**218 S LAMAR BLVD (SCHLOTZSKY PUD) REZONING (C814-2018-0121),
COMMENTS FROM ZILKER NEIGHBORHOOD ASSOCIATION
(July 24, 2020)**

PROJECTED TRAFFIC FLOW FROM SCHLOTZSKY PUD ONLY (ONE ENTRANCE/EXIT)

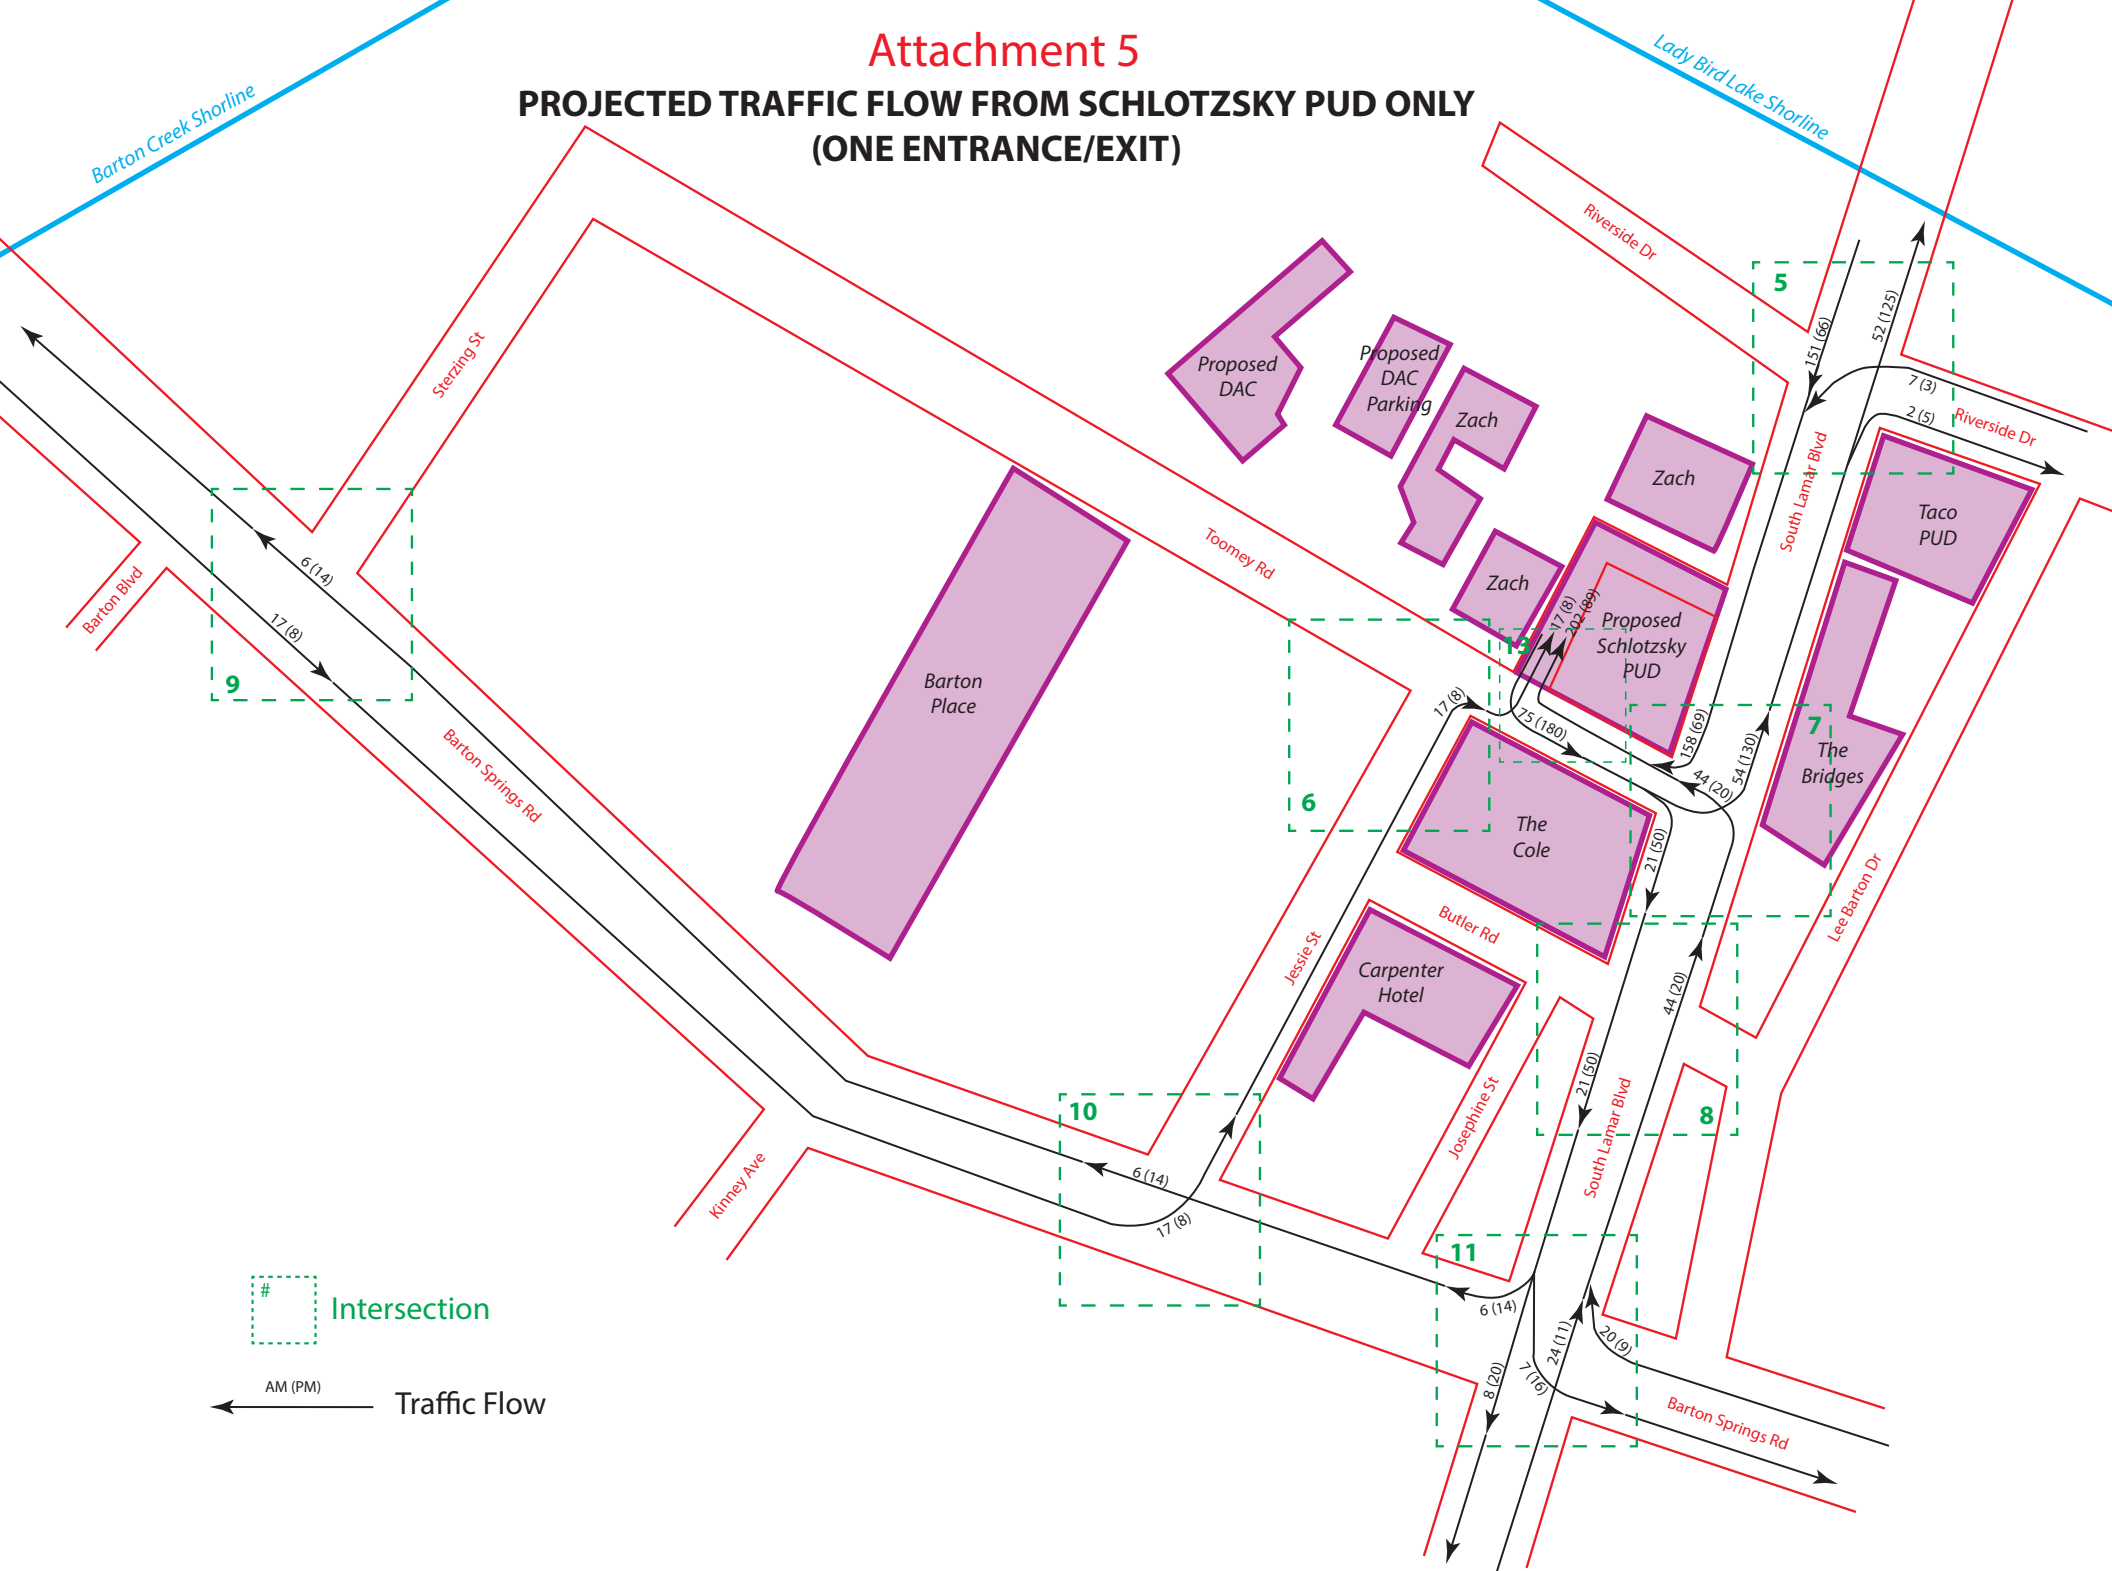
6) The projected traffic flow (see Attachment 5) is unreasonable. Even if only 8% of the trips to and from the site utilize Barton Springs Rd (west), and this seems like an extremely low number of trips, cars are very unlikely to take the path that is projected in the TIA, especially when leaving the site. Virtually no one is going to turn left onto Toomey, right onto South Lamar, and then right onto Barton Springs Rd. Instead, they will turn right onto Toomey, left onto Jessie or Sterzing, and then right onto Barton Springs, thus avoiding two signals and the South Lamar traffic.
